HISTORIC DOWNTOWN ADVISORY COMMISSION

1. CERTIFICATE OF APPROPRIATENESS

Applicant: Victoria Damiani Davis DBA SoHo Luxury Exchange
Location: 32 E Olentangy St
Zoning: DB – Downtown Business District
Request: Review and approval of exterior building and property improvements.

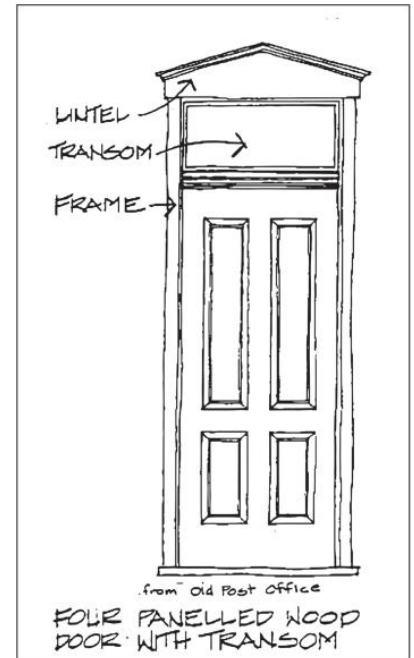
- Proposed Landscaping: Please refer to the Front and Back Landscape Plans and the “Inspirational Photos” page.
 - Staff Comments: The proposed landscaping plan will be an inviting addition to the front yard, and help to activate the site from Olentangy Street. Staff would urge the applicant to reconsider the proposed climbing plant on the west side of the building. If the Commission approves the climbing material, it must be carefully controlled by the applicant as to not damage the building materials per the PAG.
